Agenda Item # 11

SUB-003758-2026

SpringHill Villas Subdivision

SPRINGHILL VILLAS SUBDIVISION

DETAIL SITE PLAN

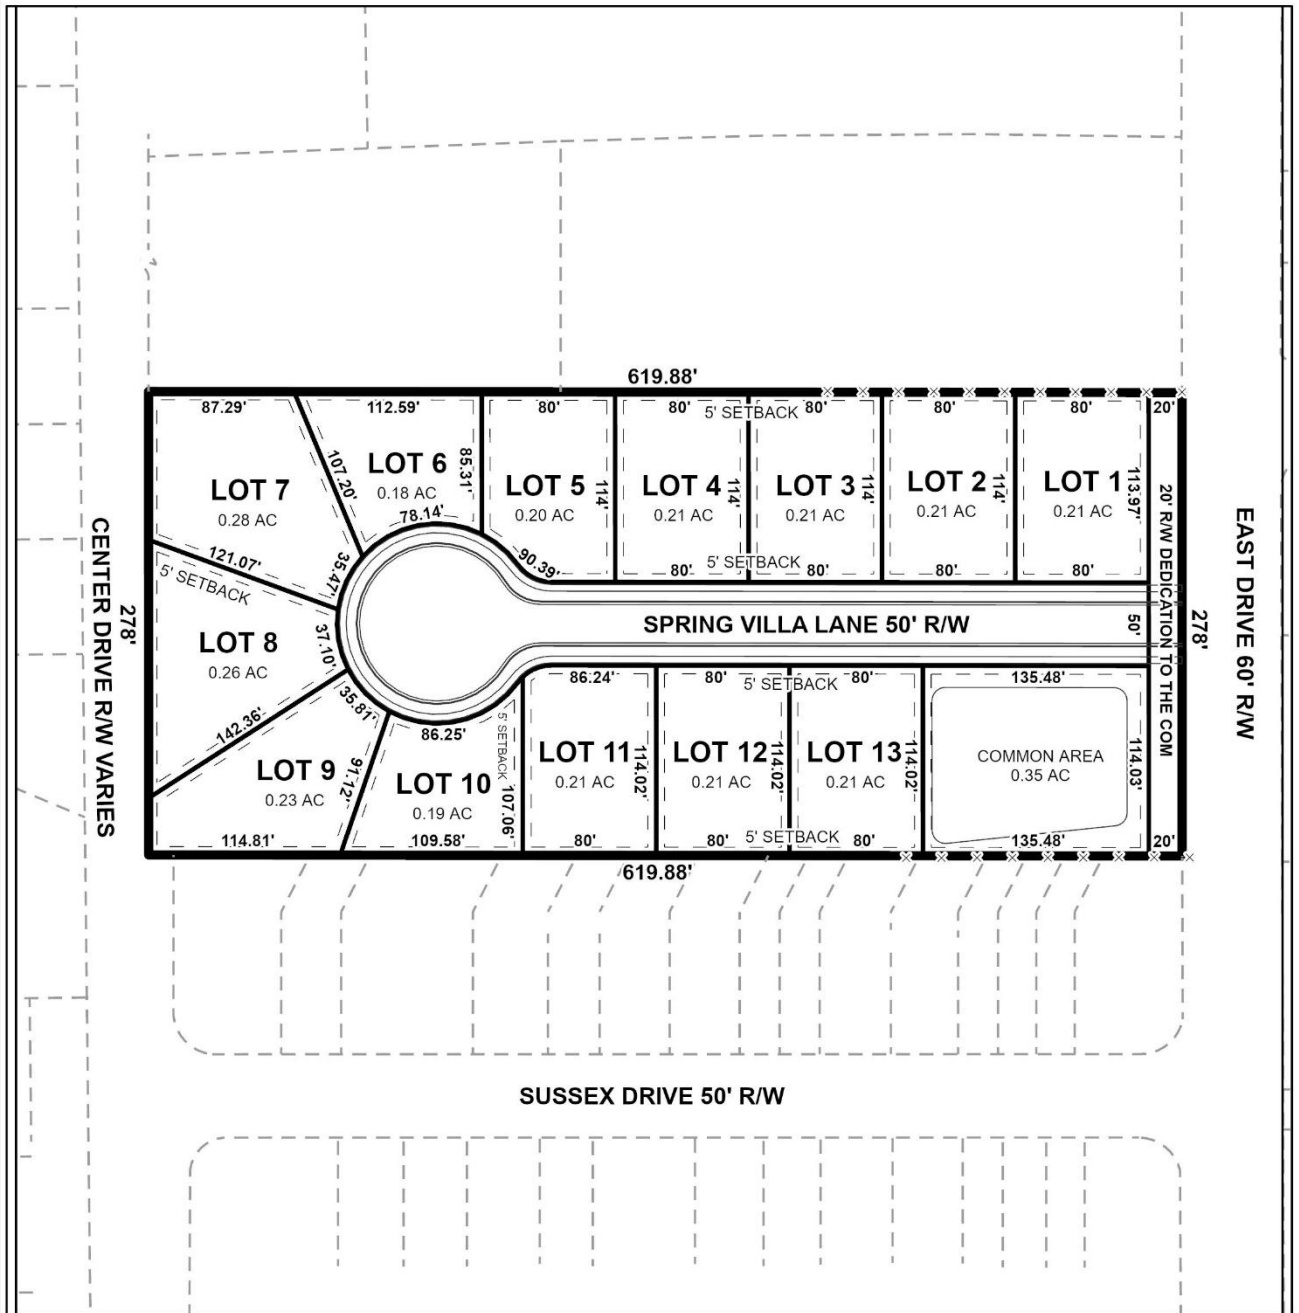
The subject site abuts East Drive, a minor street with curb and gutter. The preliminary plat depicts a compliant right-of-way width of 60 feet, making no dedication necessary. It should be noted that the plat submitted depicts a 20-foot strip along East Drive as being dedicated to the City, but this is not required. As such, the Final Plat should be revised to not include dedication to East Drive's right-of-way.

The plat submitted depicts thirteen (13) proposed lots, with a common area, that are to be accessed by a new public right-of-way, proposed to be named Spring Villa Lane. The plat depicts Spring Villa Lane as having a 50-foot-wide right-of-way, which is compliant for a street with curb and gutter. There is also a compliant cul-de-sac at the end of the street.

It should be noted that the proposed Lots 7, 8, and 9 are less than the minimum required width of 60 feet. As such, if approved, Section 6.C.2.(b)(2) of the Subdivision Regulations must be waived.

Per Section 6.C.7. of the Subdivision Regulations, double frontage lots, such as the proposed Lot 1 and the Common Area should be limited to one (1) street for access. As such, if approved, a waiver of Section 6.C.7. of the Subdivision Regulations will be required, and a note should be placed on the Final Plat stating that Lot 1 and the Common Area are denied direct access to East Drive.

The UDC requires newly platted R-1 Suburban lots to have a 25-foot front setback. The preliminary plat submitted does not depict front setbacks. If approved, the Final Plat should be revised to depict a 25-foot setback along both East Drive and Spring Villa Lane.

1. Removal of the proposed dedication of 20 feet along East Drive;
2. Placement of a note on the plat stating that Lot 1 and the Common Area are denied direct access to East Drive;

7. Revision of the plat to illustrate a 25-foot front setback for all lots and the Common Area along both East Drive and Spring Villa Lane;
8. Compliance with all Engineering comments noted in this staff report;
